**ADDENDUM NO. 1**

Relocate Airfield Lighting Vault  
Quonset State Airport  
North Kingstown, Rhode Island

**RHODE ISLAND AIRPORT CORPORATION**

April 4, 2013

SHEET TITLE: CIVIL  
**ELECTRICAL VAULT SITE PLAN - BMPS, PAVEMENT DETAILS, & BORINGS**

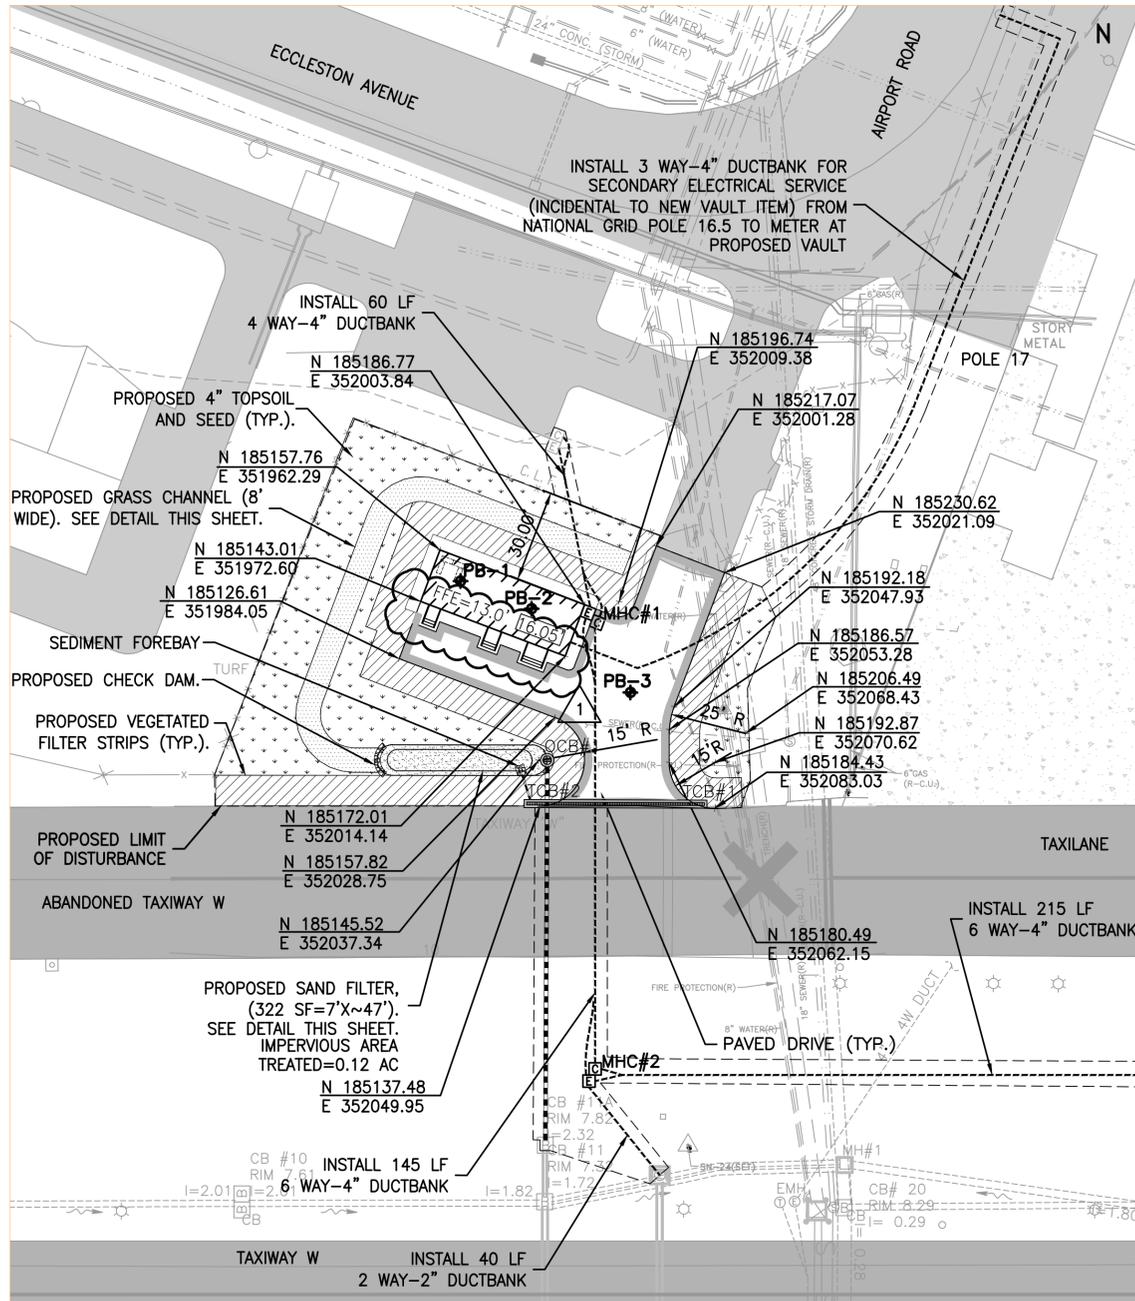
- Q2. The site plan on sheet C-7 seems to show the paved driveway area overlapping with the proposed concrete sidewalk. Please clarify the limits of each.  
A2. The sidewalk will encircle the building. The pavement will meet the sidewalk.

- Q3. Please provide a detail for the "Proposed Vegetated Filter Strips" that are called out on the site plan on sheet C-7  
A3. The "Proposed Vegetated Filter Strips" shall follow the requirements of the item T-905 Topsoil and Seeding.

**2 REINFORCED CONCRETE SIDEWALK**  
SCALE: NOT TO SCALE

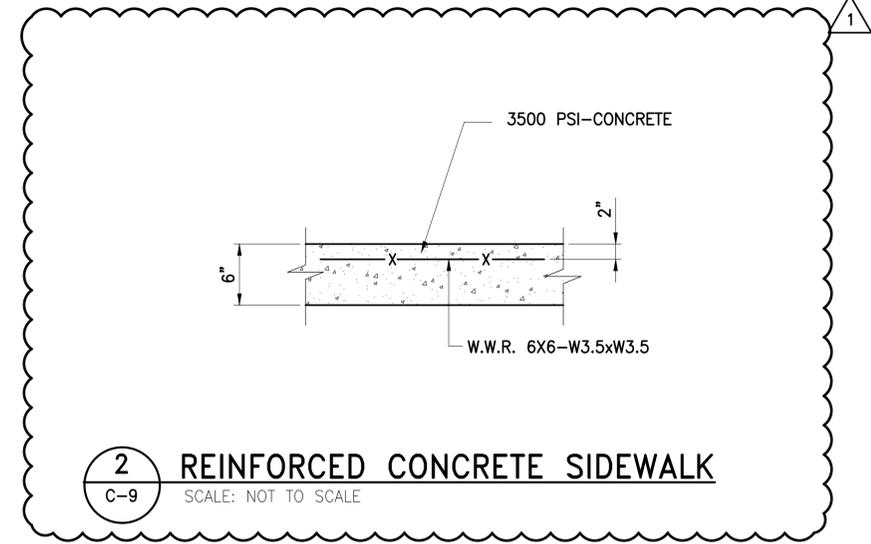
- Q1. Please provide a detail for the reinforced concrete sidewalks called out on sheet A-3.  
A1. Reinforced Concrete Sidewalk detail has been added to Sheet C-9 by this Addendum.

**1 TYPICAL CONCRETE PIPE CRADLE DETAIL**  
C-10 SCALE: NOT TO SCALE

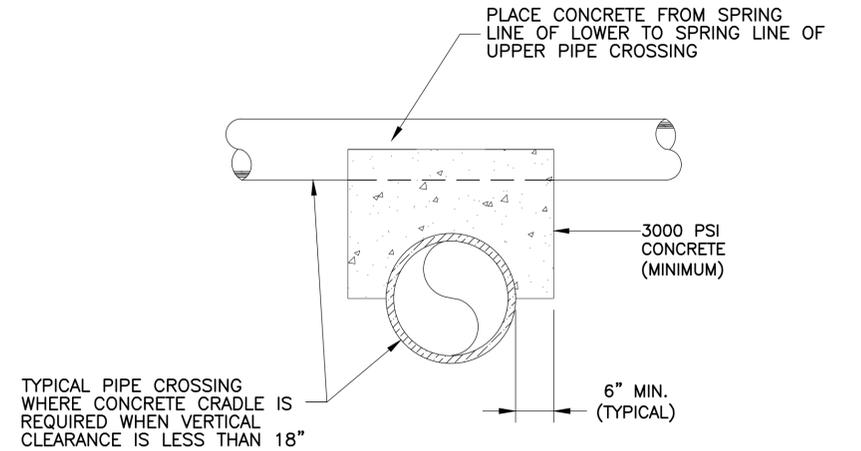
“Existing utilities that have less than three inches (3”) vertical clearance shall be encased in concrete for ten feet (10’) on both sides of ductbank crossing. Existing utilities that have vertical clearance less than eighteen inches (18”) shall have a concrete cradle per the detail shown in the plans. The concrete encasement of existing utilities and concrete cradle shall be considered incidental to the ductbank item.”

**6 TYPICAL TRENCH DETAIL**  
E-8 NOT TO SCALE

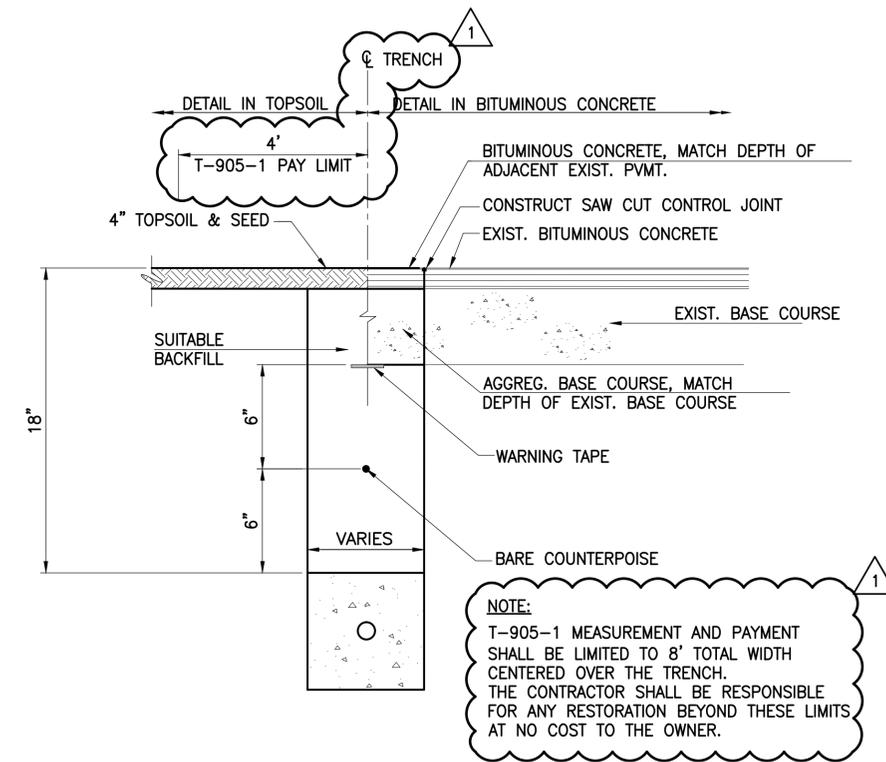
14	S-6	Revised Building Finished Floor Elevation in Details
15	S-7	Revised Building Finished Floor Elevation in Detail 1
16	E-7	Added Topsoil Pay Limits to Detail 6
